PRESENTATION AT IPC MEETING IN YASS 12TH NOVEMBER 2018

Coppabella Wind Farm – Site visit outcomes

Coppabella Wind Farm - Environmental Assessment for Modification One

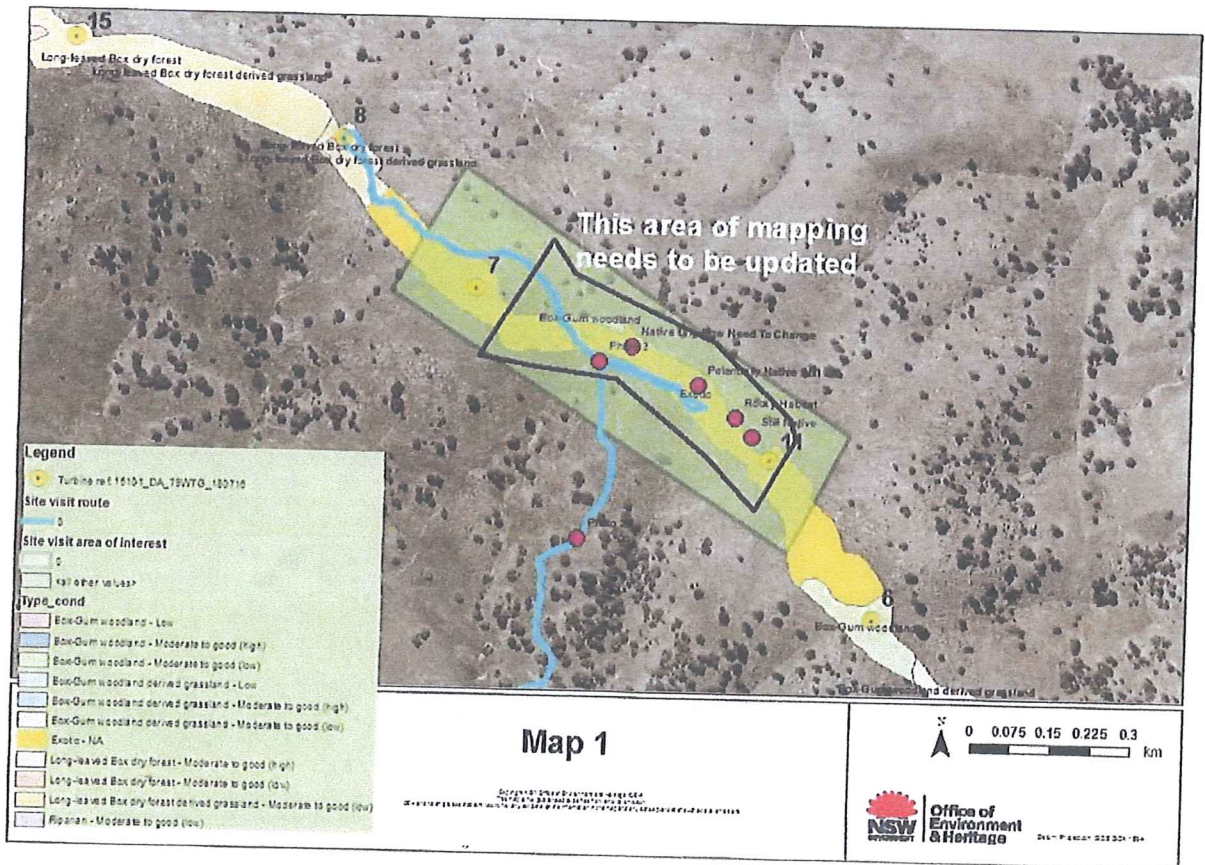
<p>Whitefield's Road</p>	<p>644625 6147433</p>	<p>Box Gum Woodland moderate to good (low)</p>	<p>The site inspection confirmed this area is of very high-quality vegetation with an intact grassy understory and a canopy with a high density of tree hollows.</p>	<p>Agreed that this was probably one of the highest ecological areas of the whole site. Avoid any disturbance to roadside vegetation</p>	
<p>Red point FID 0</p>	<p>644889 6150055</p>	<p>Box Gum Woodland Derived native grassland moderate to good (low)</p>	<p>This area is good quality habitat, surrounded by lots of seemingly degraded pasture to the south. Yet the road goes through the quality habitat area.</p>	<p>Move road to the south to avoid impacts on this area.</p>

Request to Reject:

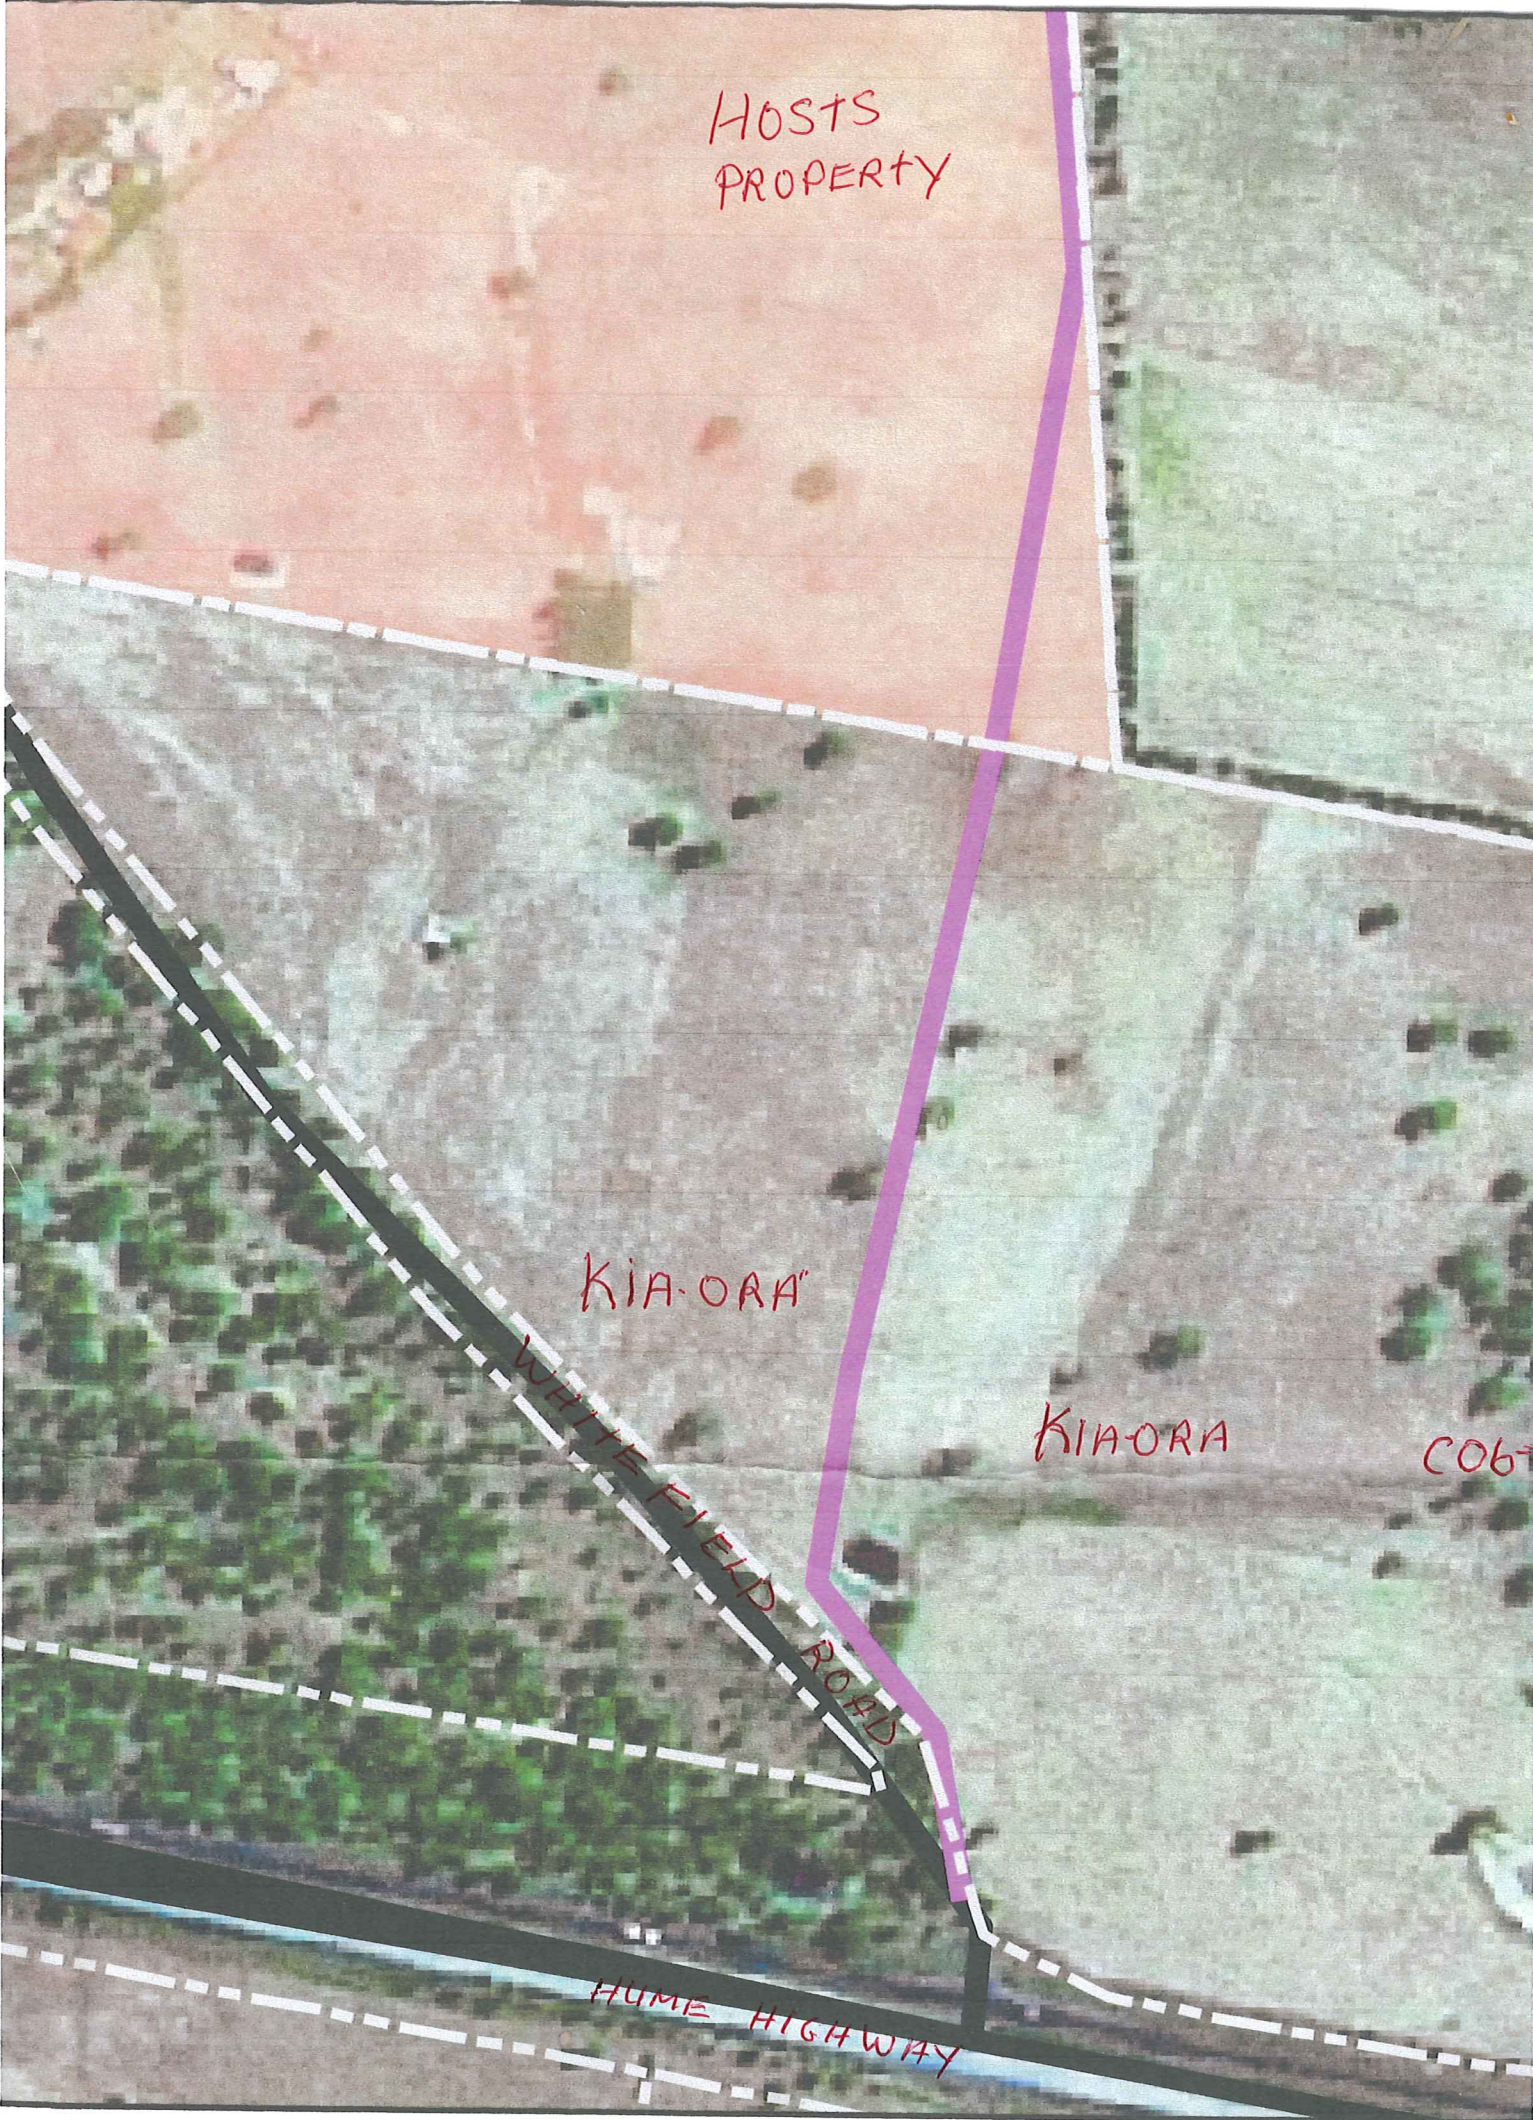
Coppabella South Precinct

Whitefield Road

Turbines: 73,74,78,79,80-(81,82)

Turbines: 73 & 74 to Marilba Precinct
